CITY PLAN COMMISSION STAFF REPORT

Project Name
Plaza East Apartments

Request
CD-CPC-2022-00192
Development Plan - Residential

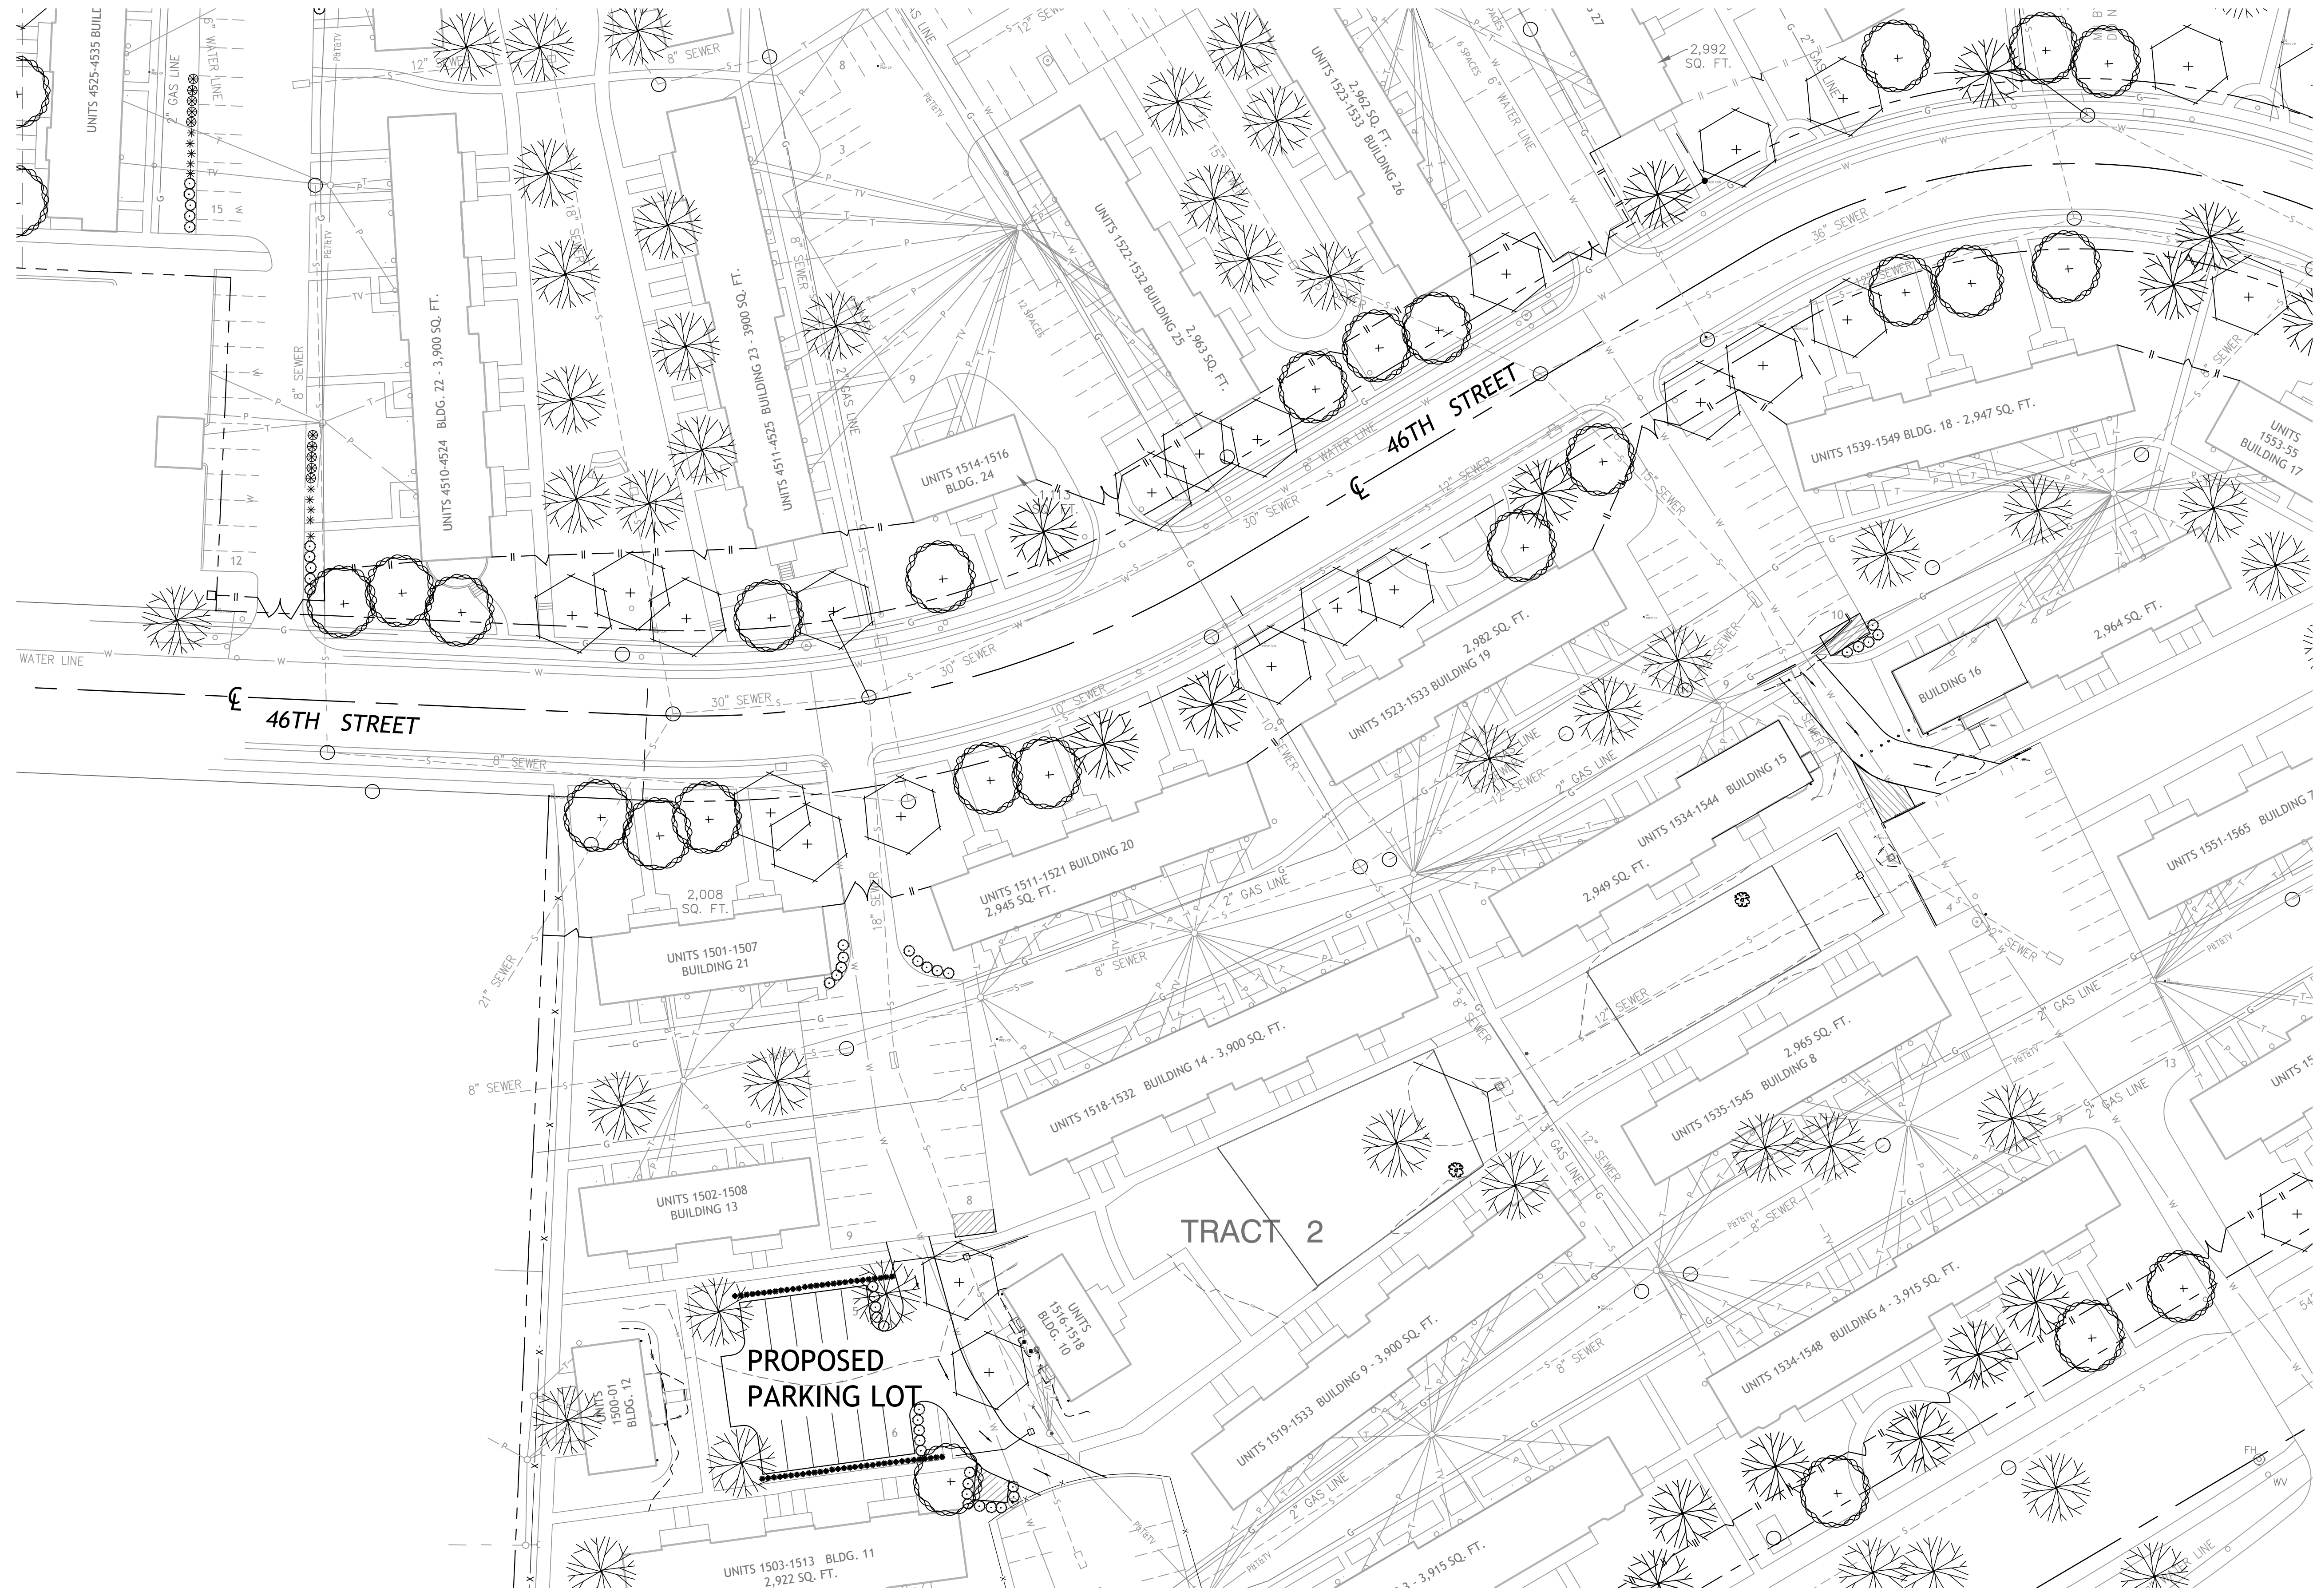
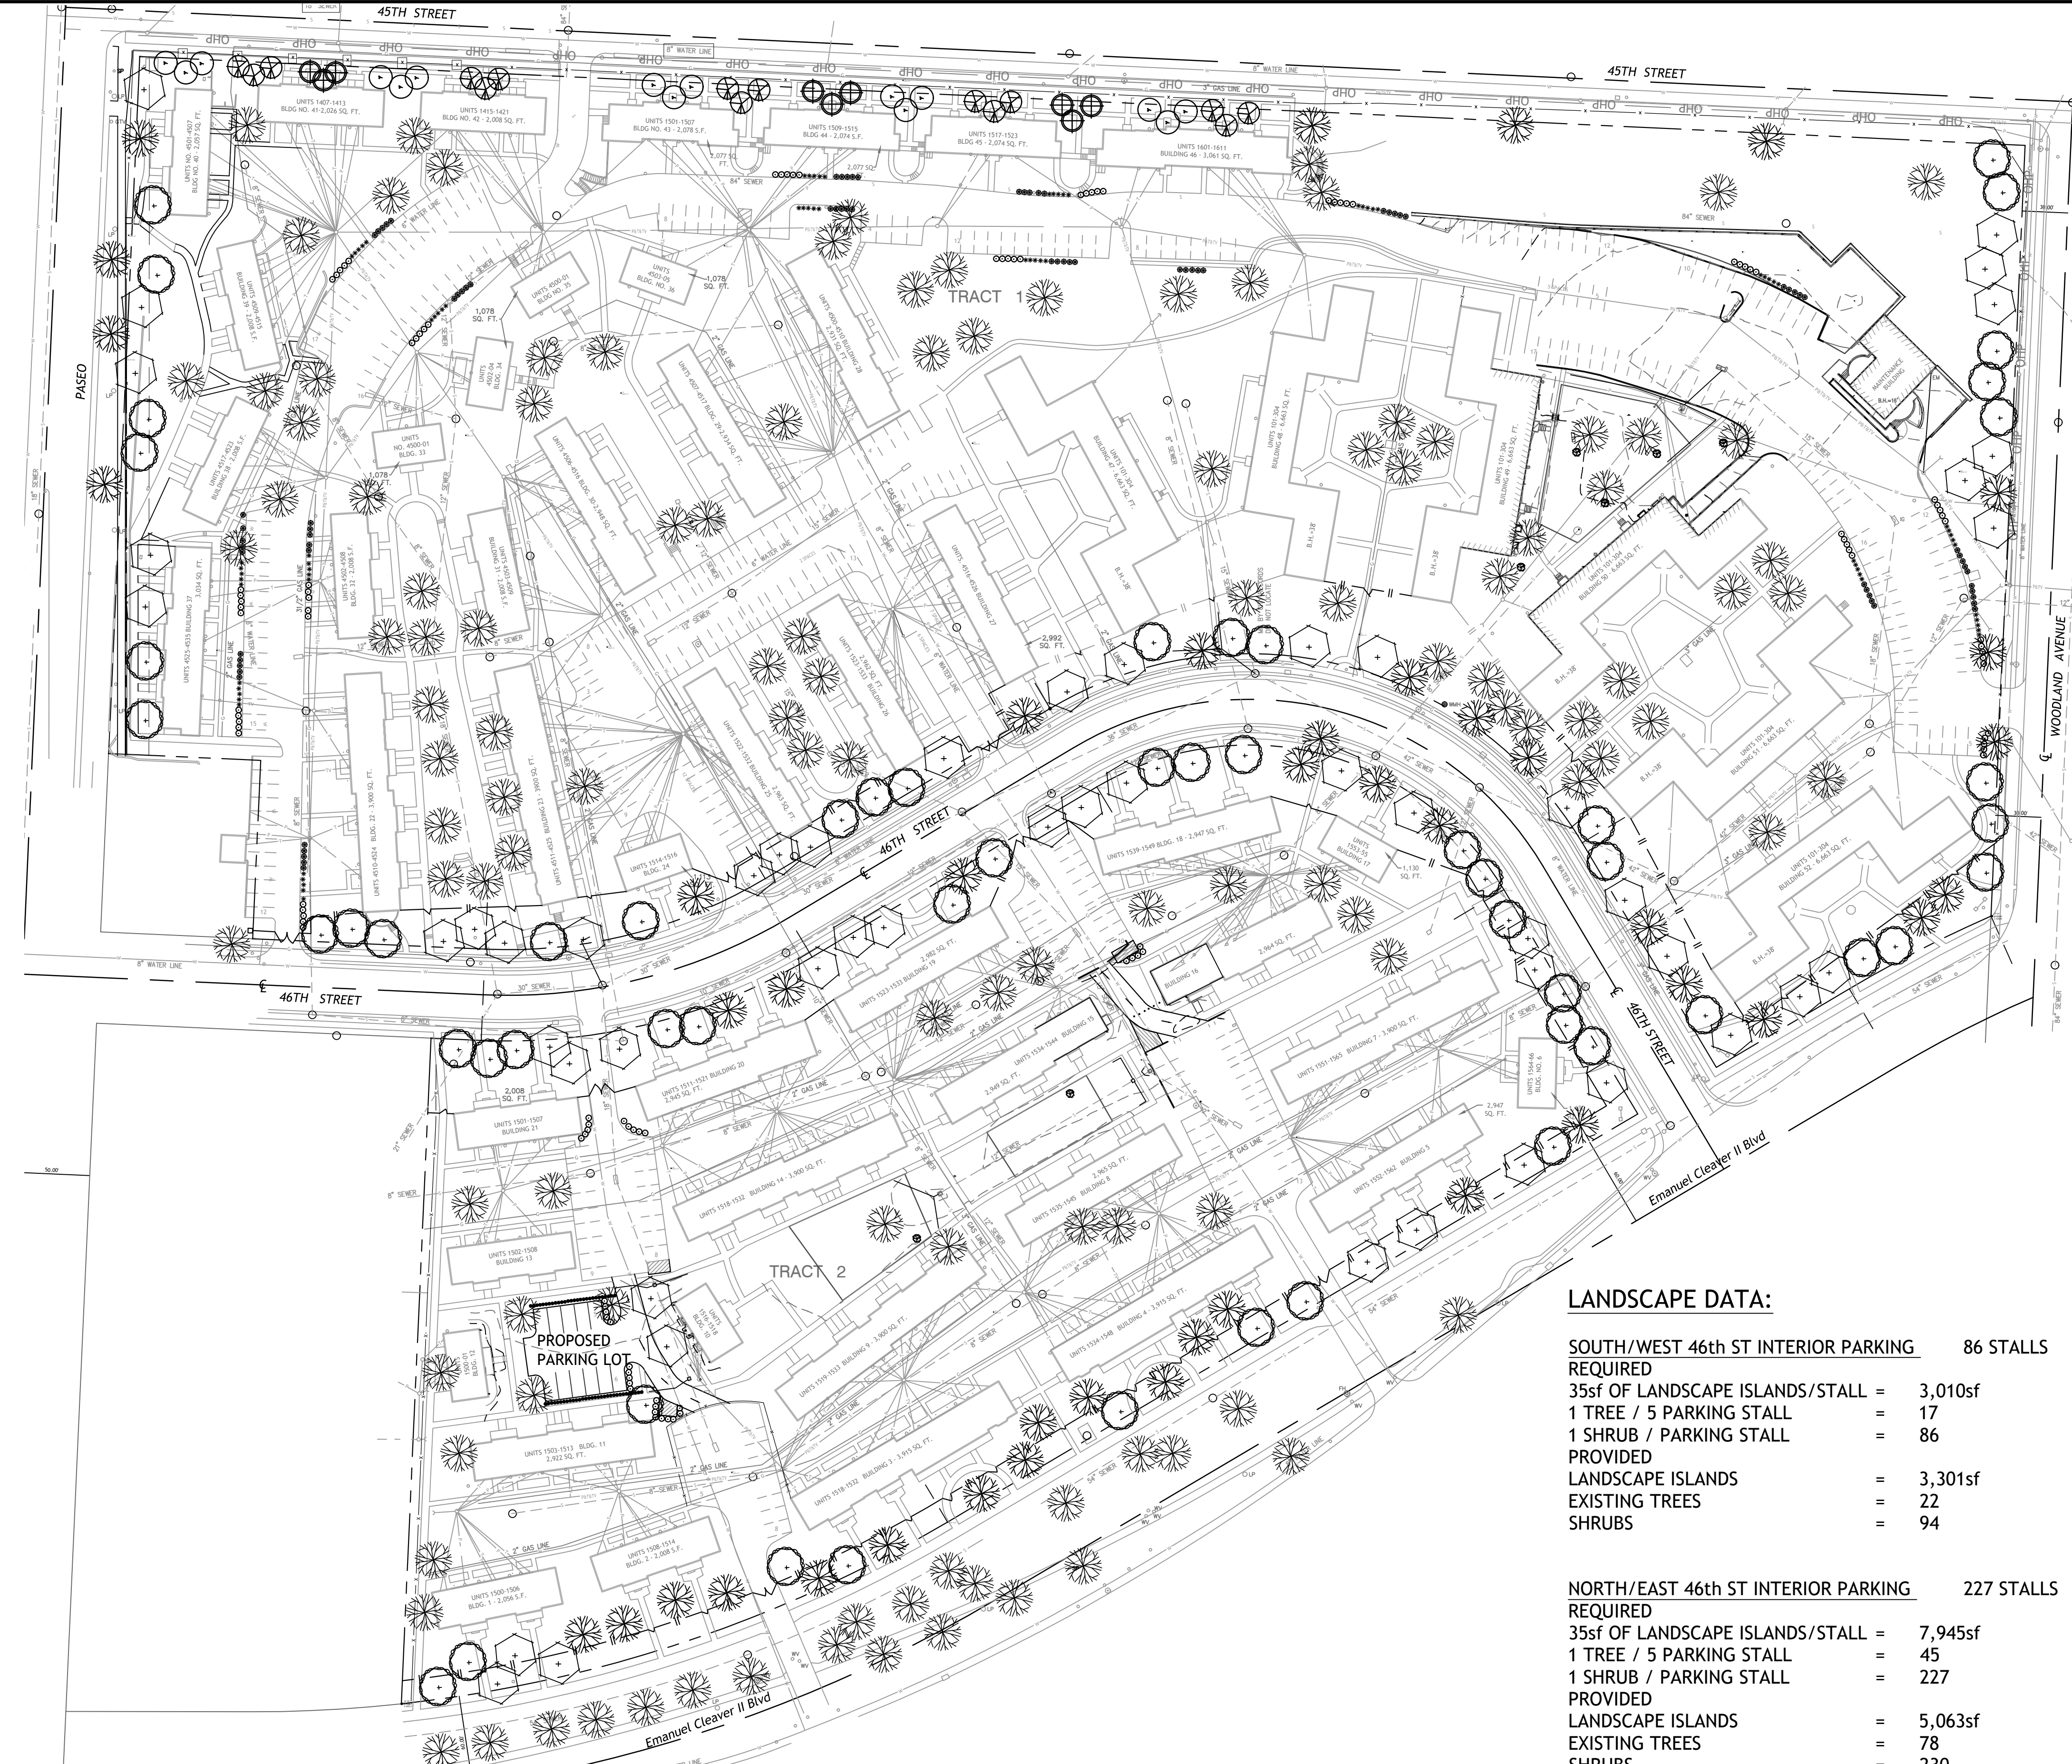
4. That all signage shall conform to 88-445 and shall require a sign permit prior to installation.
5. Prior to ordinance request the developer shall revise the landscape plan to remove and replace all invasive species.
